ADDENDUM NO. 1
TENDER NO. 4-19
AUBIN ROAD REHABILITATION

February 15, 2019

CITY OF WINDSOR
PUBLIC WORKS - ENGINEERING DEPARTMENT
TENDER 04-19 - AUBIN ROAD
SEWER AND PAVEMENT REHABILITATION
TECUMSEH ROAD EAST TO GUY STREET

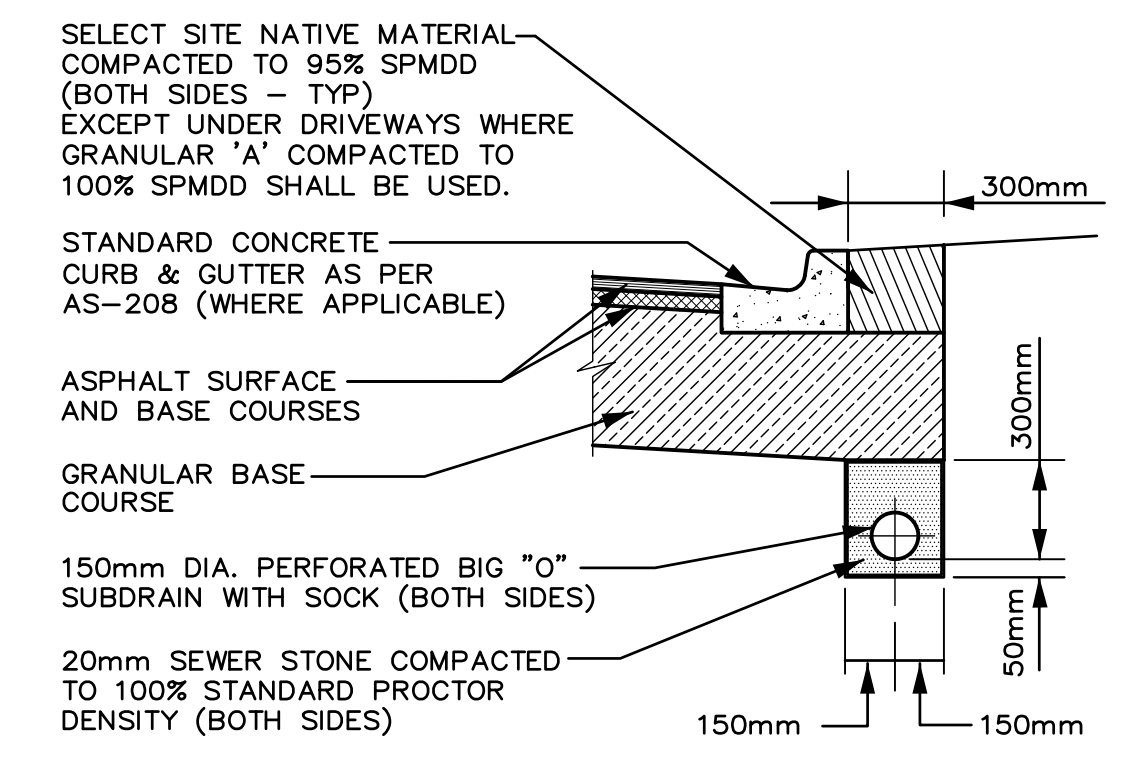
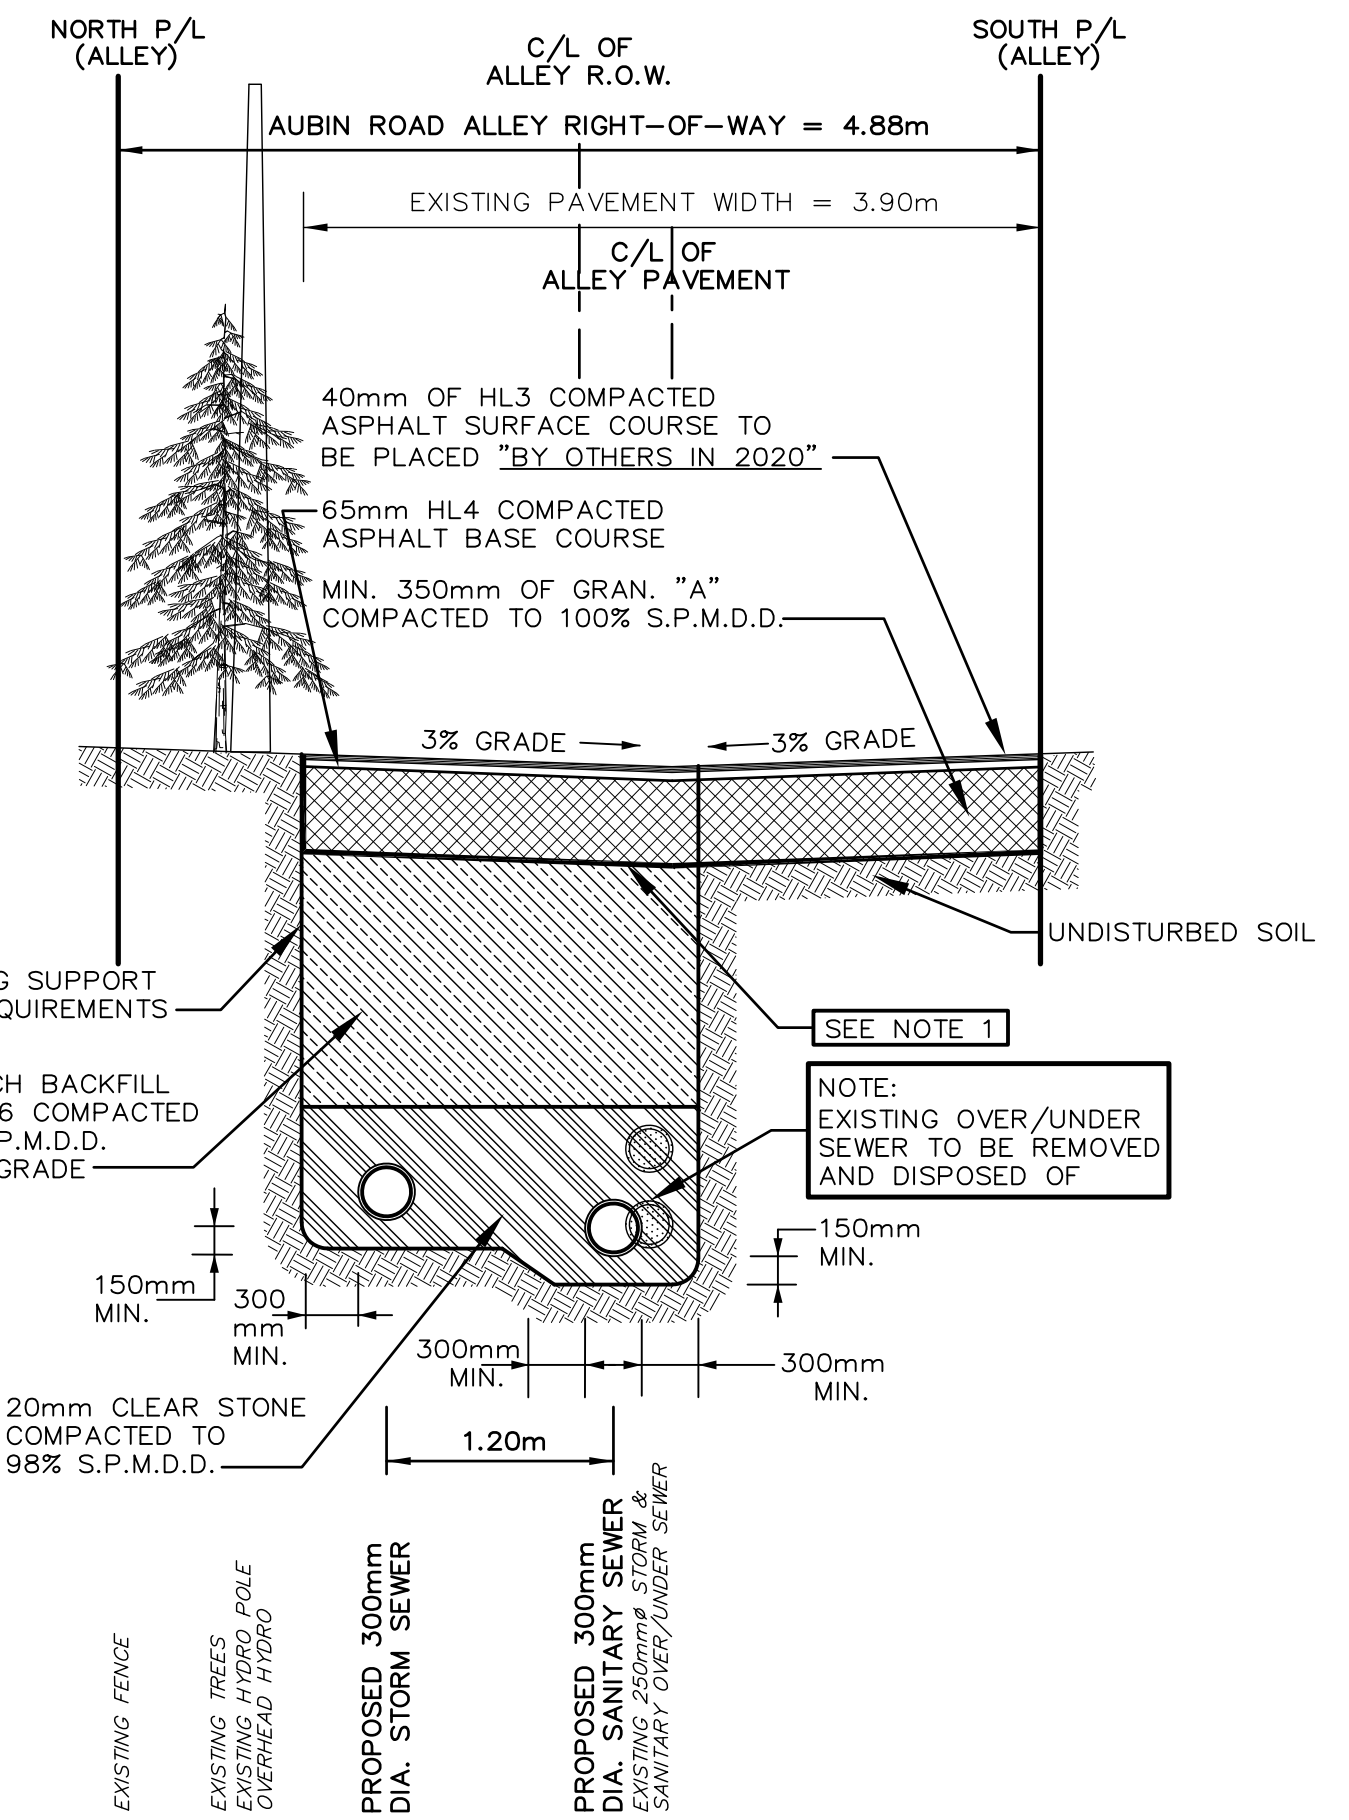
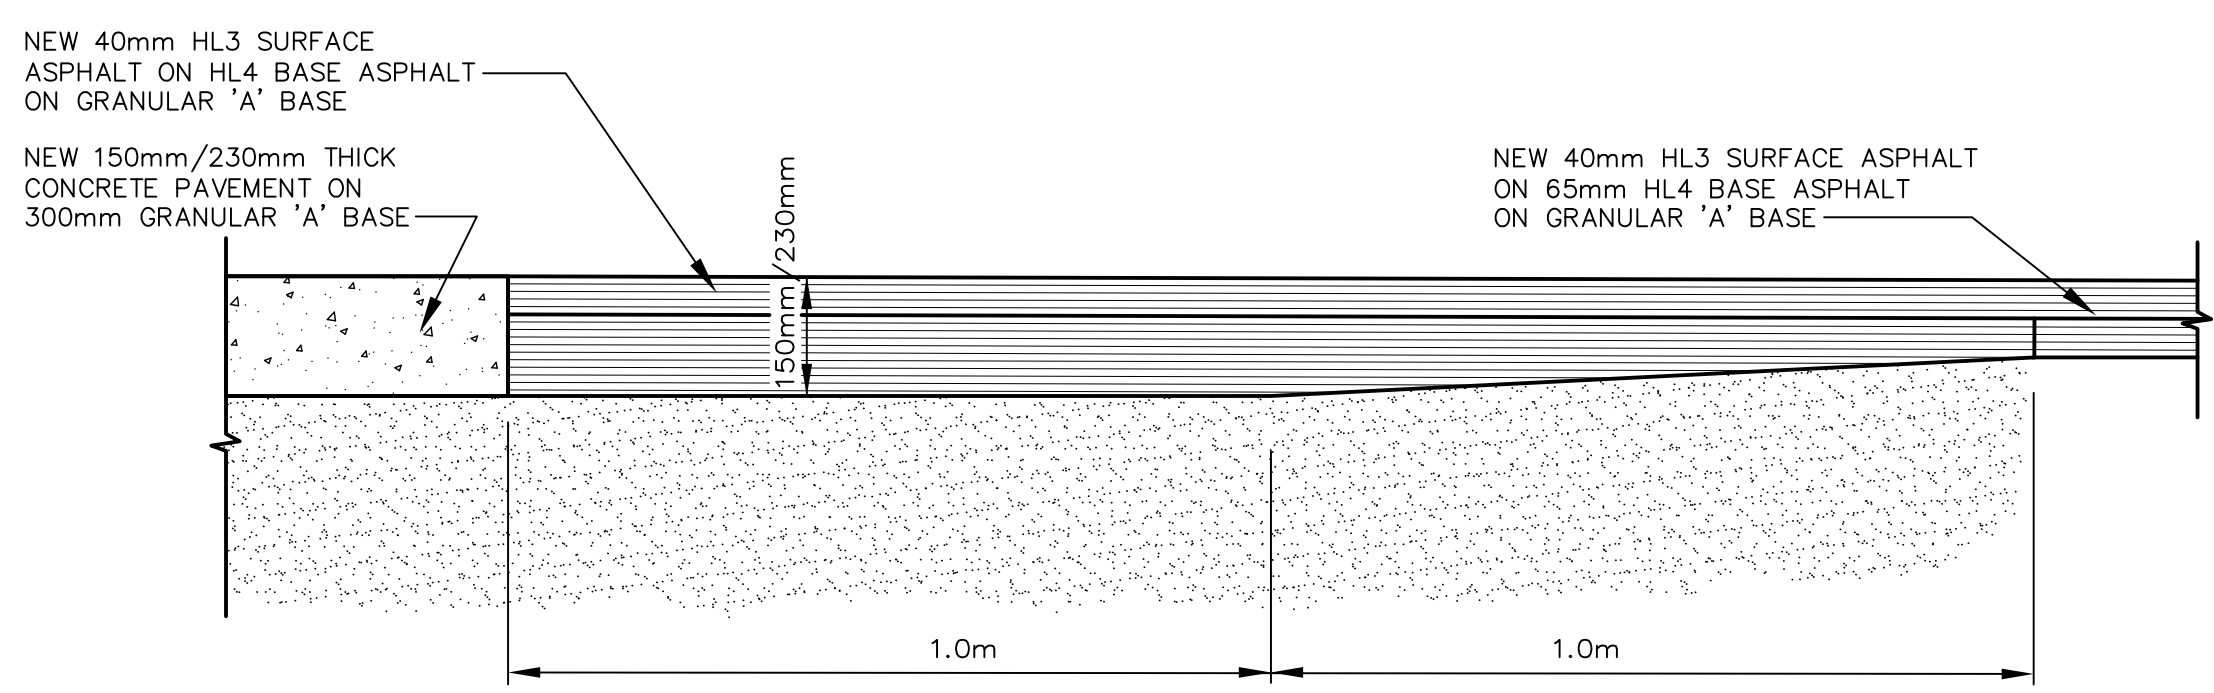
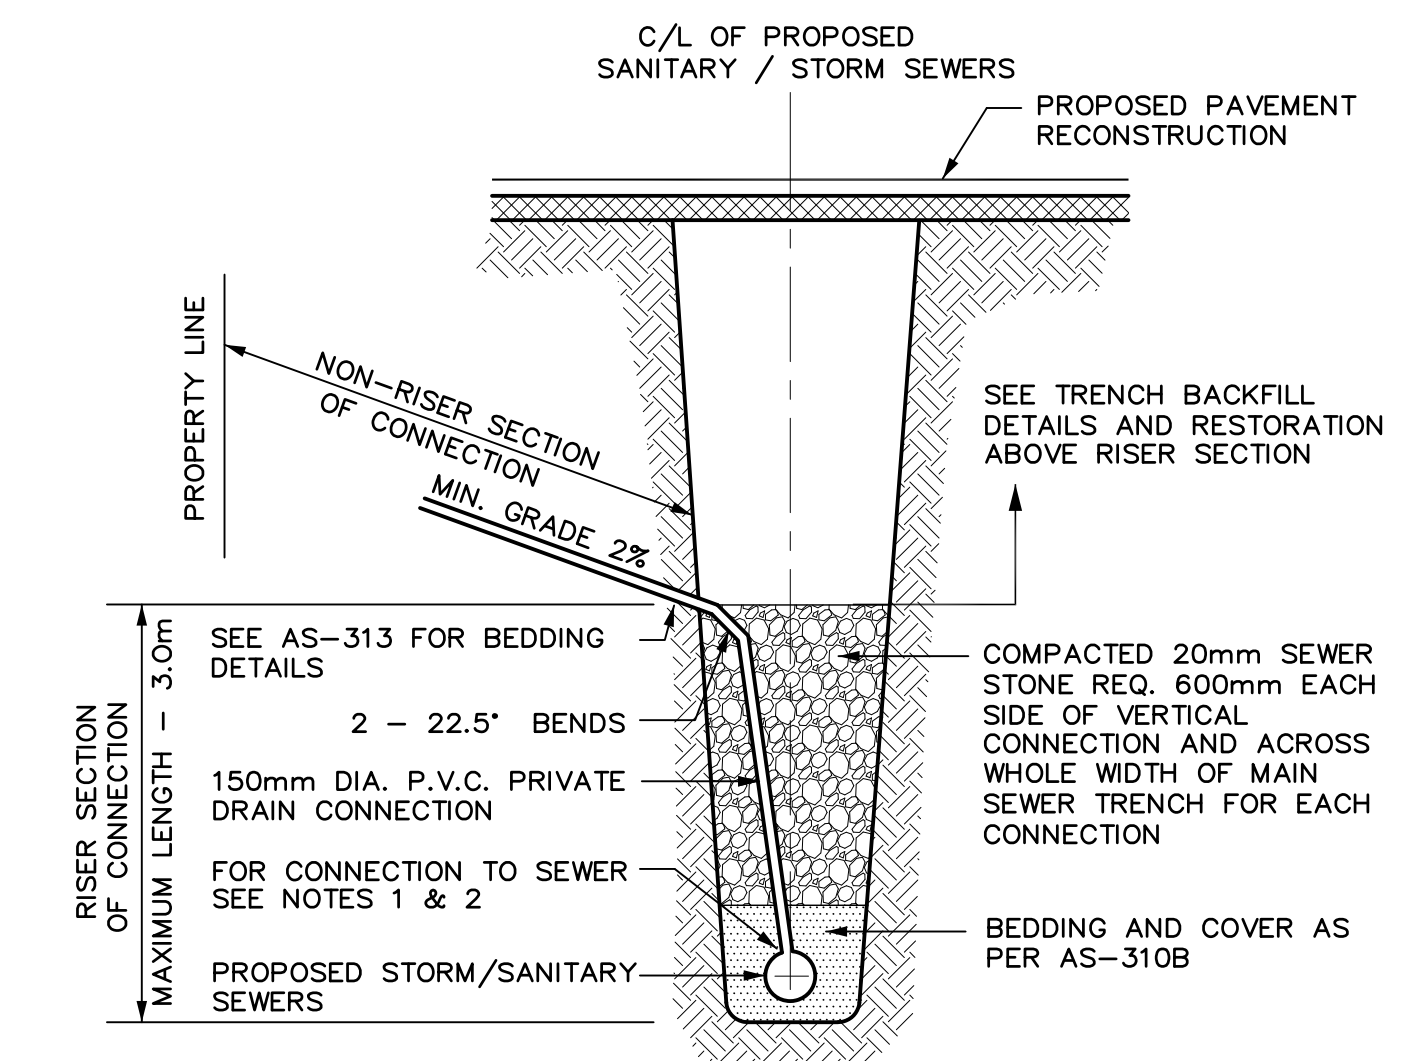
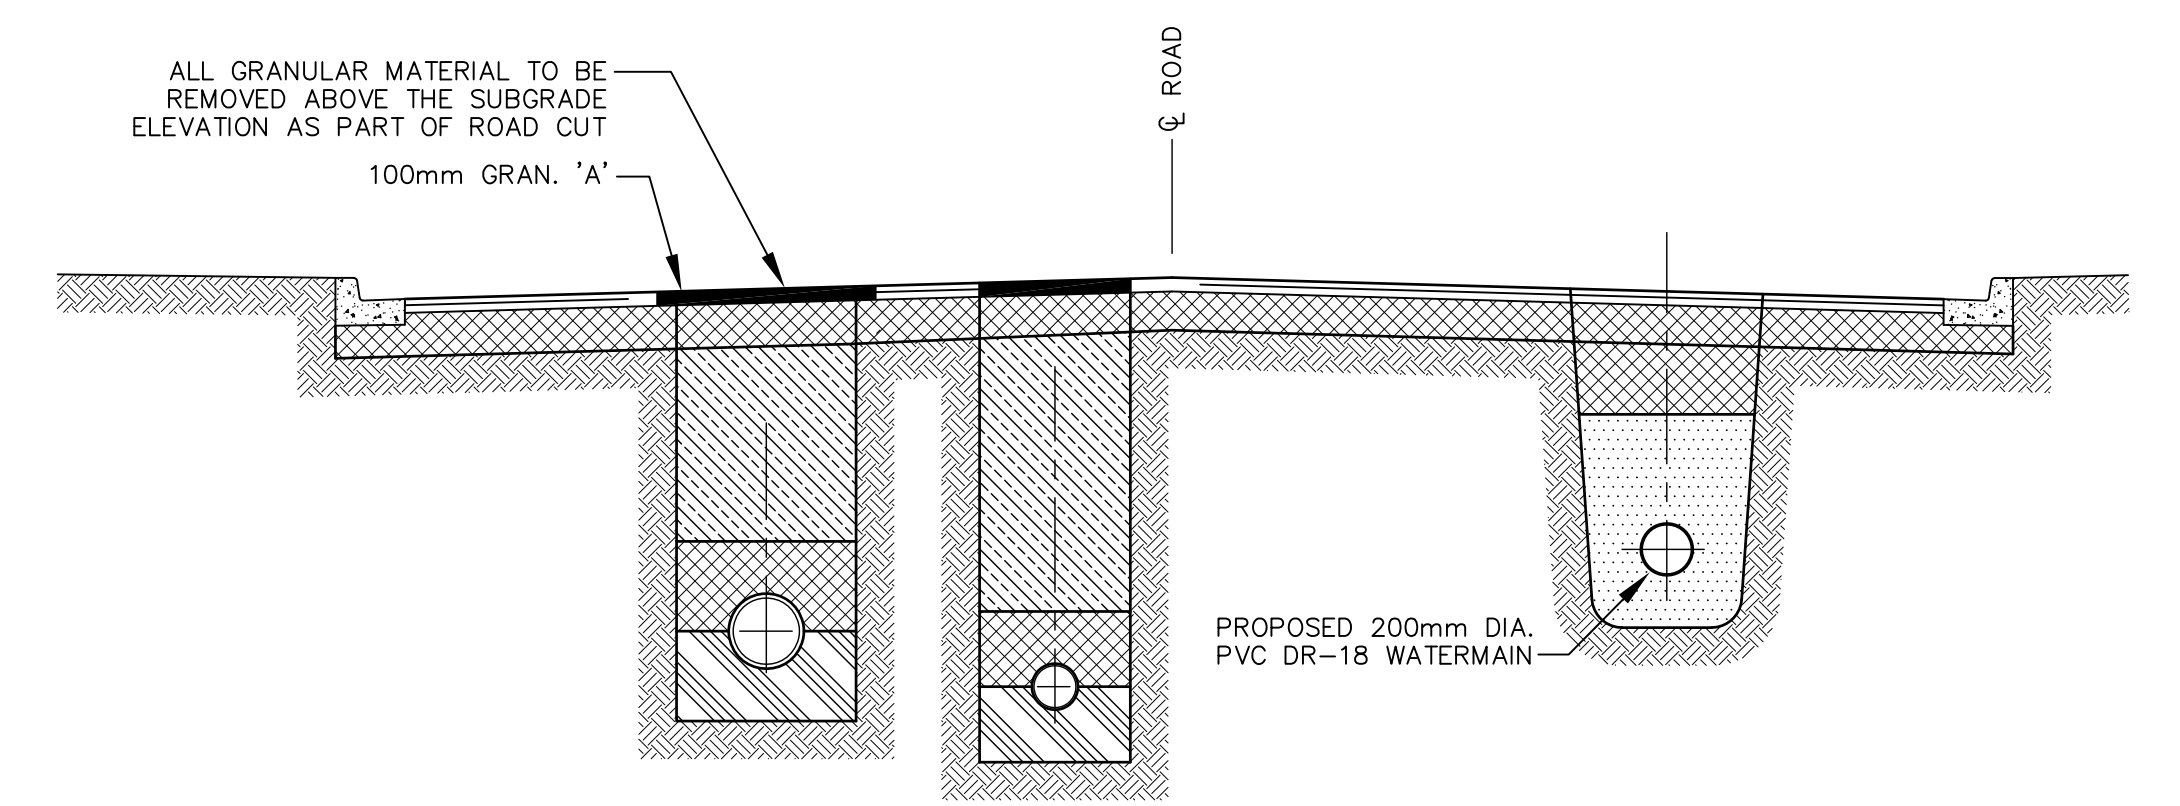
- The sewer elevations and profile on drawings S-2068 sheet 1 is correct. See sheet 4 for changes – attached for reference
